CALIFORNIA CENTRAL VALLEY  
**FLOOD CONTROL**  
ASSOCIATION

**SUBJECT: Comments on Flood Risk White Paper**

## **Comments to the Flood Risk White Paper Delta Stewardship Council October 18, 2010**

DELTA LEVEES PROGRAM  
TYPICAL EXAMPLES OF LEVEE IMPROVEMENTS

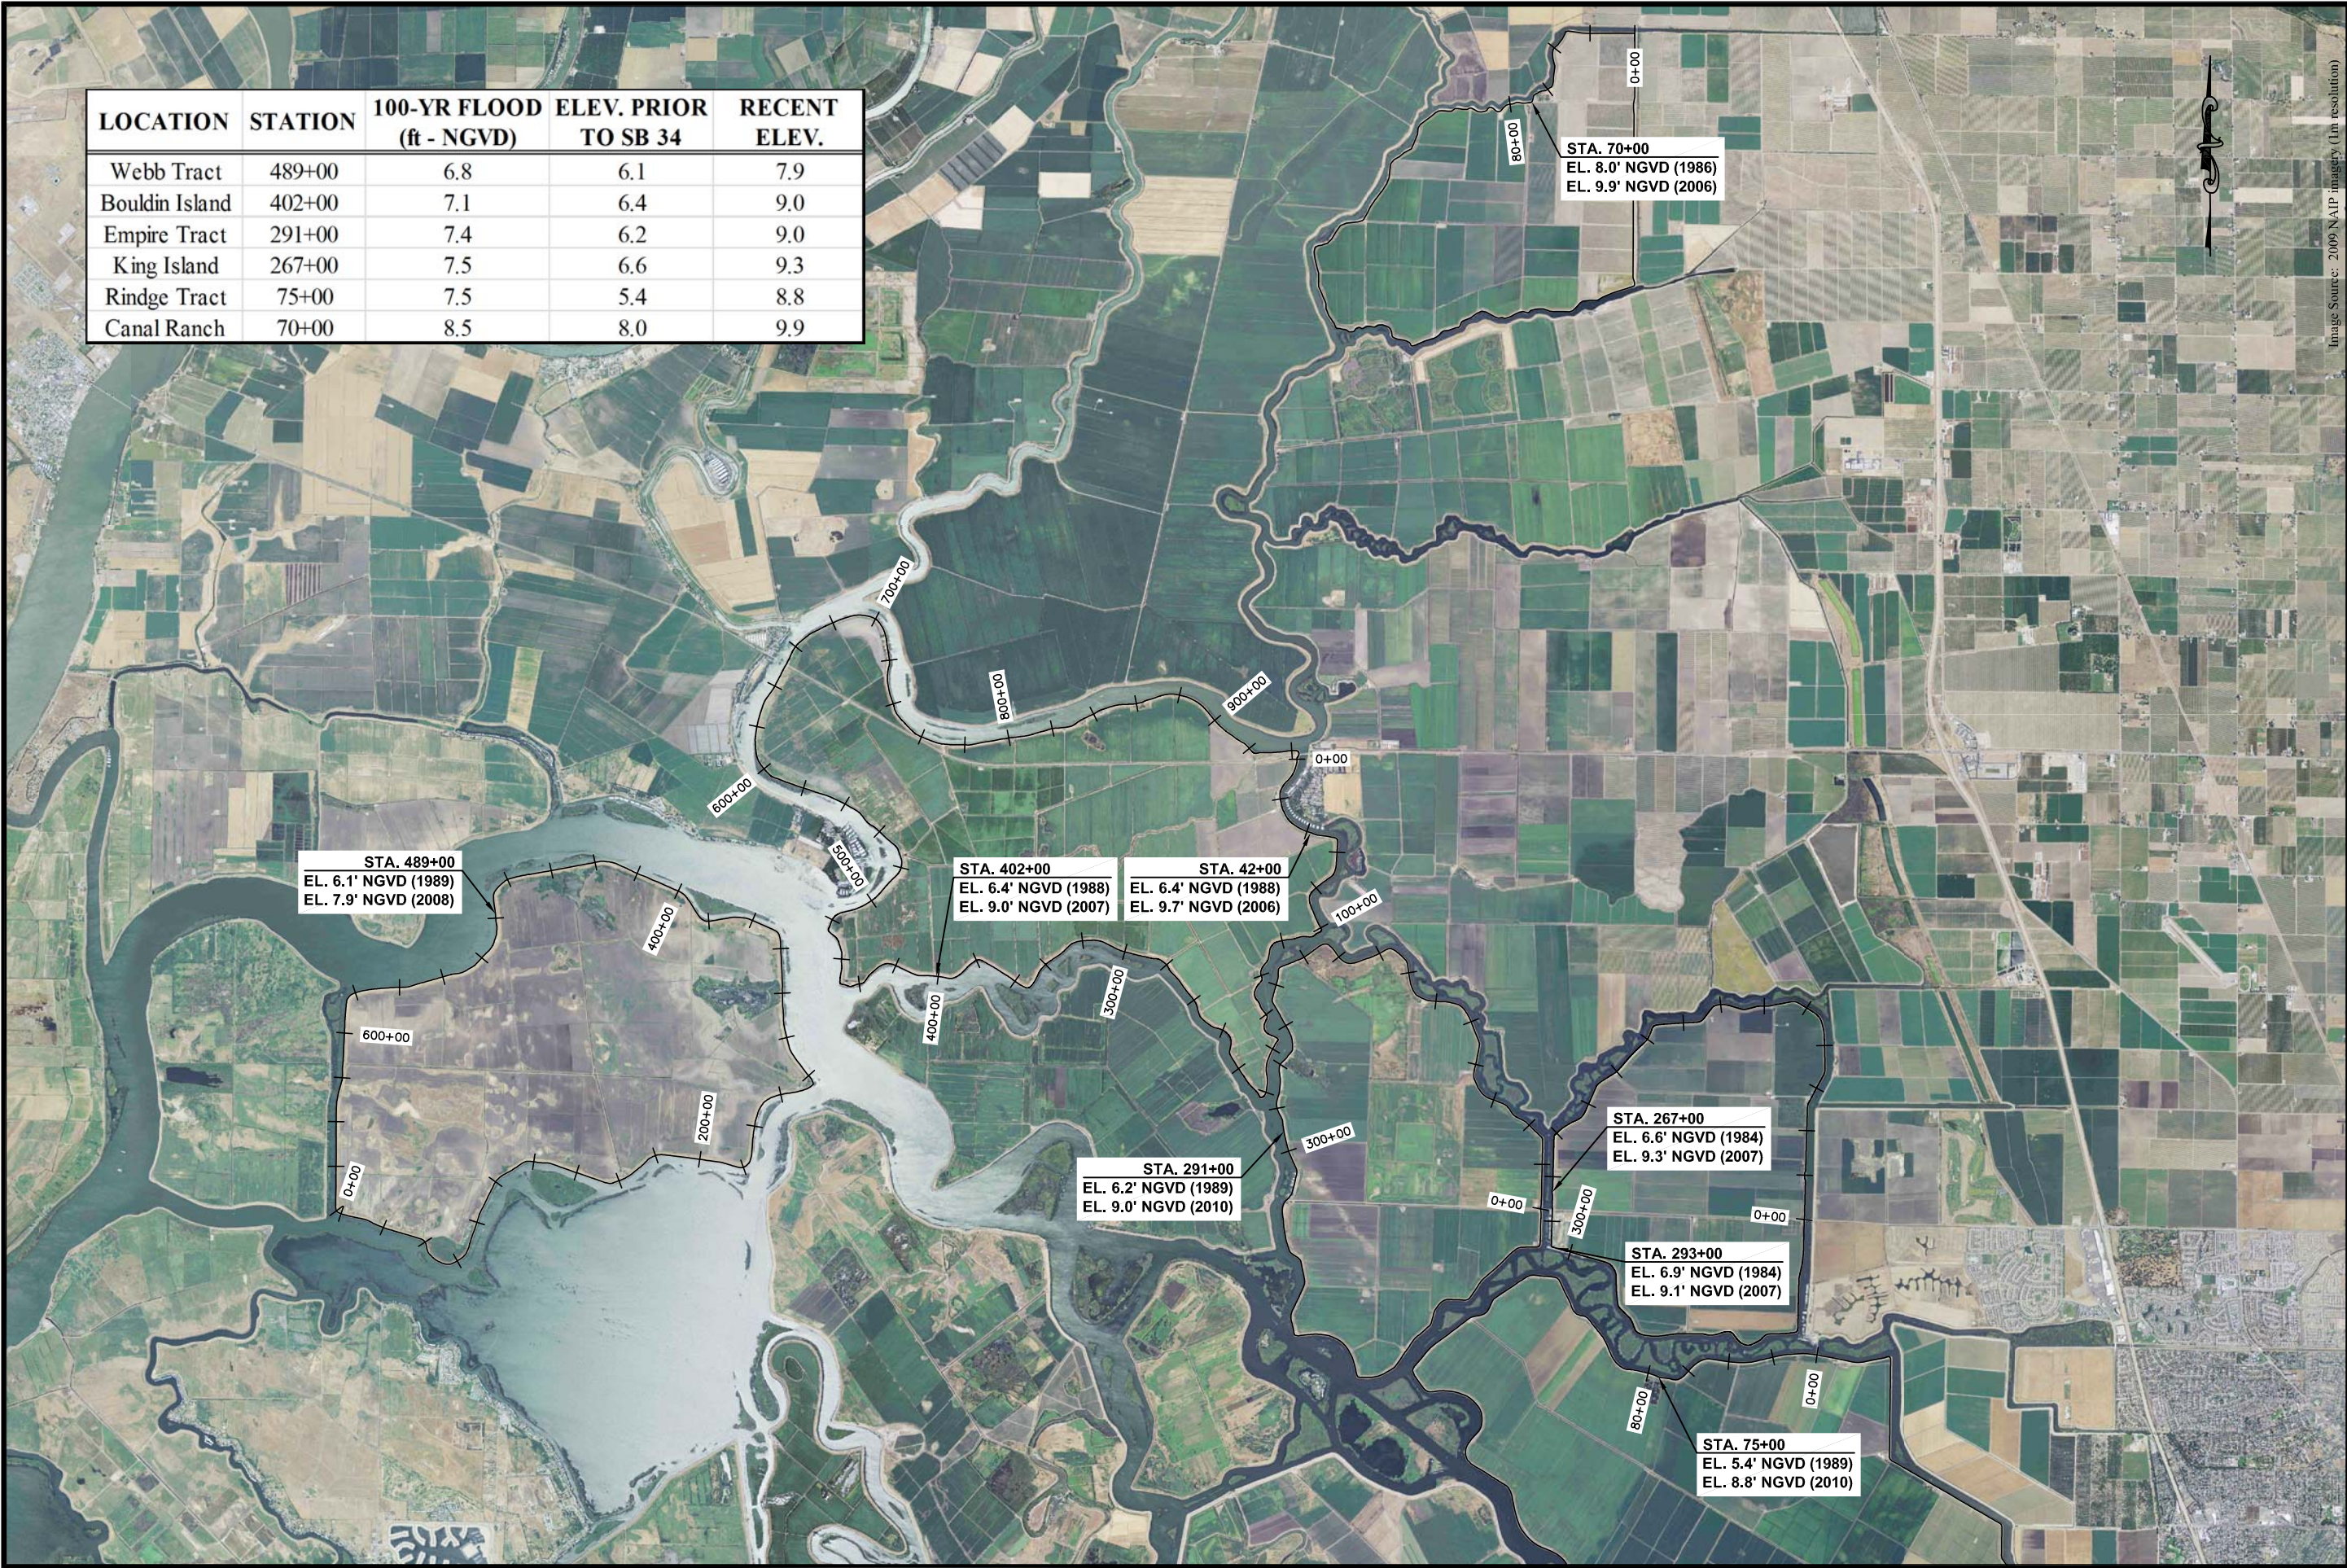
1. Page No. ES-1, Lines 22 through 29: This section discusses the un-sustainability of business as usual. One of the problems with the recent studies that have been performed on Delta levees is that they don't adequately look at the state of the levees in the mid-1980's and the improvements to the levees after the increased funding provided by SB34 and subsequent legislation. This is a key issue due to the fact that the increased funding provided by Props 1E and 84 (2006) will set the stage for future levee condition. The fact of the matter is at the end of the 2006 proposition funding, levees will be in a much more advanced state. This should be considered by the Delta Stewardship Council in the development of its plan. Plate 1 shows the major improvements within the past 20 years where central Delta levees have been raised several feet in some areas. Based on these types of improvements and funding provided over the past 20 years, we are confident the levees will be in a much better state following expenditure of Propositions 1E and 84 funding.
